20 FEB 1986

**NAVIGATION AND VESSEL INSPECTION CIRCULAR NO. 4-85 CHANGE 1**

**Subj: Change 1 to NVIC 4-85 of 29 May 1985, Subj: Recalls and Other  
Corrective Measures for Lifesaving and Fire Protection Equipment**

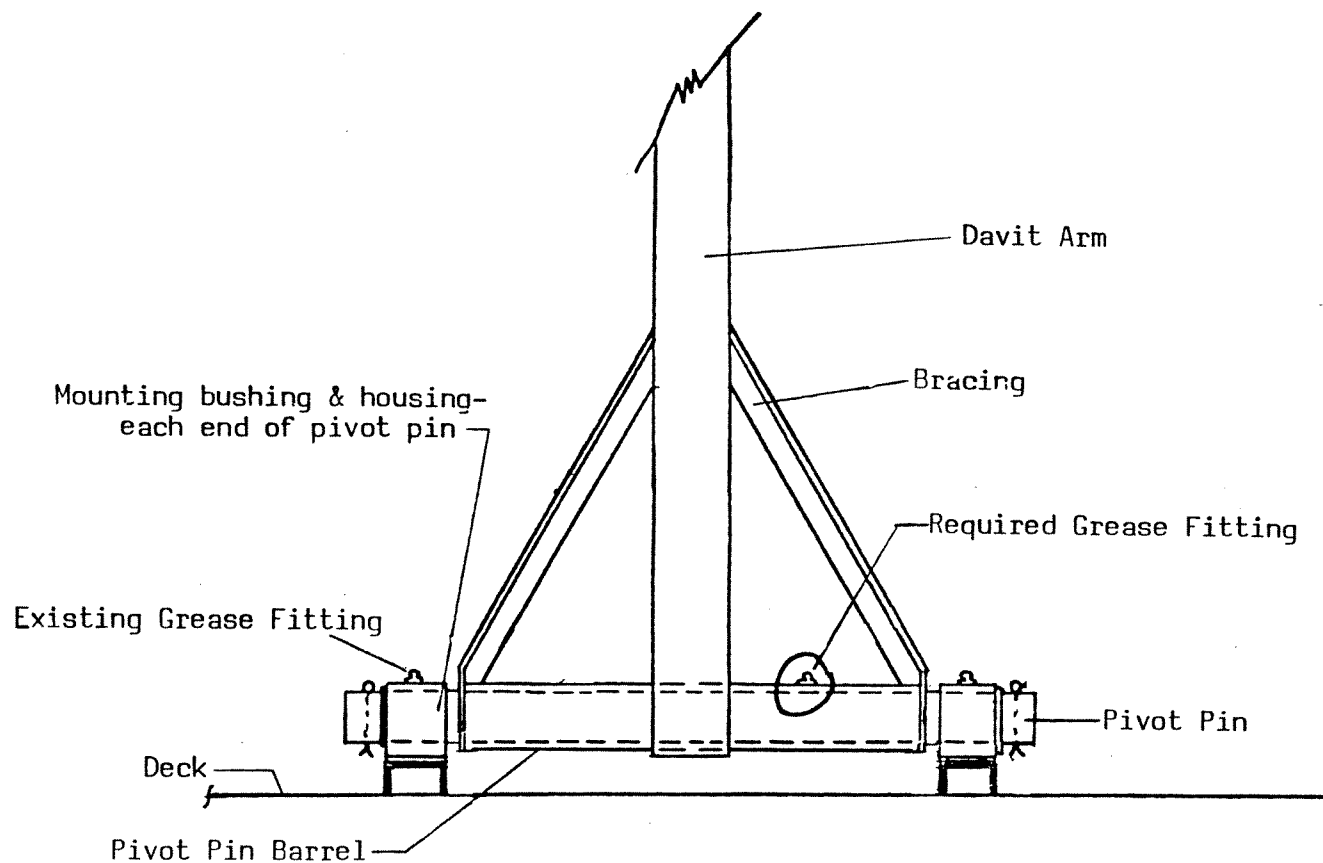
1. PROBLEM. The safety pin on the Titan release gear operating handle used in certain Watercraft America lifeboats, can be inserted before the handle is in the safe, fully closed position. In this condition, the release hooks may appear to be fully closed, but may unexpectedly open when a load is applied.

- a. Titan release gear with approval number 160.033/69/0 must be modified. Titan gear that has been modified can be identified by the cover plate over the old safety pin hole (item 5 on the drawing on the following page), and by the plate added to the release gear handle to accommodate the new safety pin location (see "NEW LOCATION FOR SAFETY PIN" on the drawing).

3. ACTION.
  - a. Vessel and MODU operators having Watercraft America lifeboats equipped with Titan gear having approval number 160.033/69/0 shall make sure the release gear is modified in accordance with Watercraft America drawing SP-201 and Engineering Instruction P-131, both dated 28 October 1985. The Coast Guard Officer in Charge of Marine Inspection shall be notified before the modification work begins. The drawing and instruction may be obtained from:

**ILLUSTRATION 2**

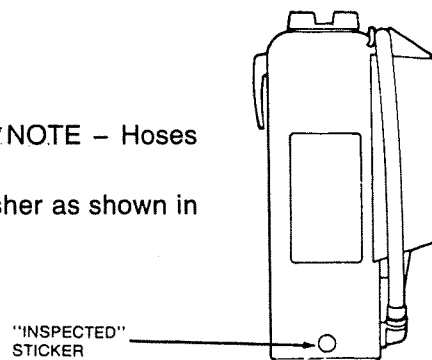
7. If it is an Ansul Model 20 Hand Portable with EX-589 Hose, check hex nut between hose and nozzle on hose assembly. If part number is preceded by an "H" (Example - H6305) or if hex nut is notched as in illustration 2, hose assembly is good, go to step 9.

8. If hex nut is **NOT** notched or part number has **NO** H, (Example - 6305) replace hose assembly, destroy old hose.
